Transmitter equalization feedback and MDIO control

(In support of comment #i-9)

Adee Ran
Intel Corporation

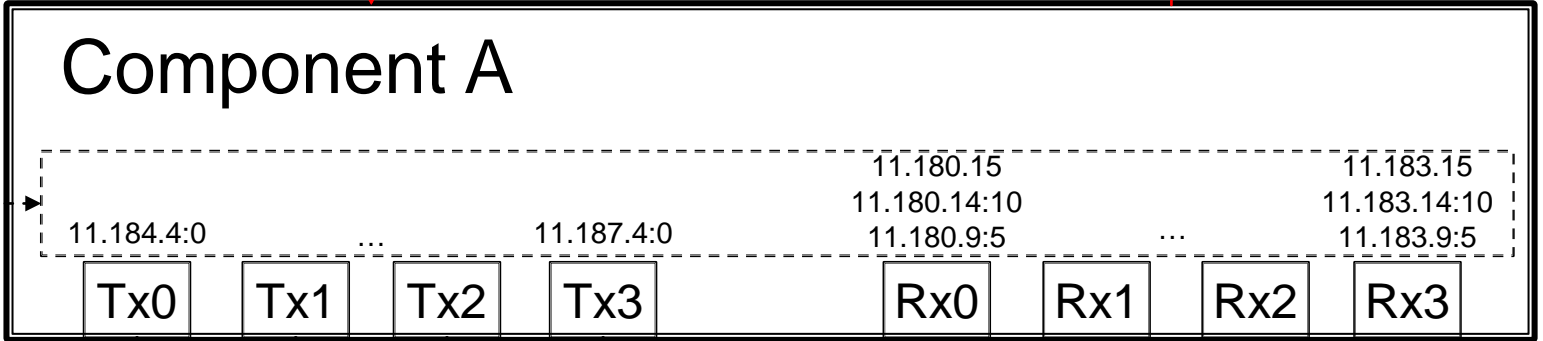
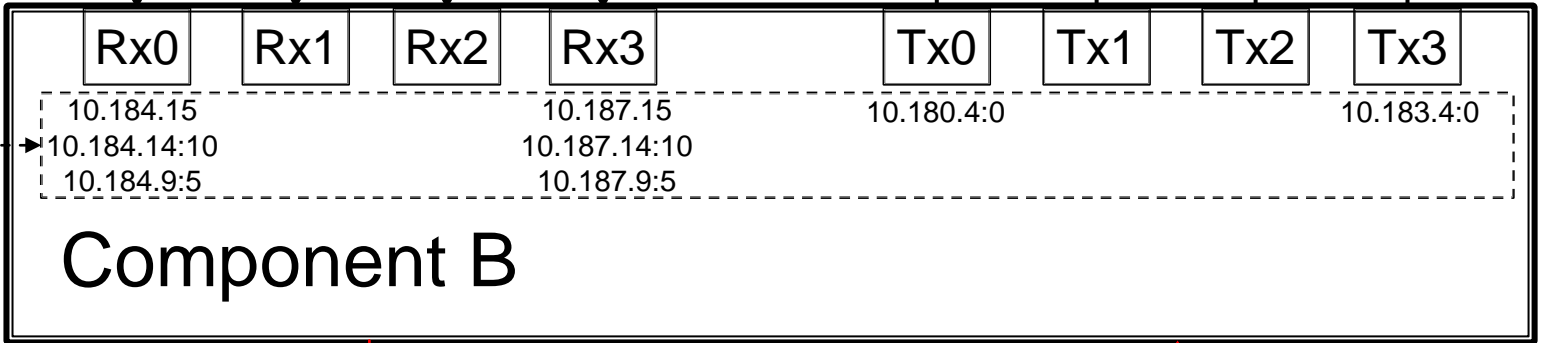
Figure 83D-5 depicts the components of the CAUI-4 chip-to-chip link and the registers used during the tuning procedure.

(insert Figure 83D-5 here)
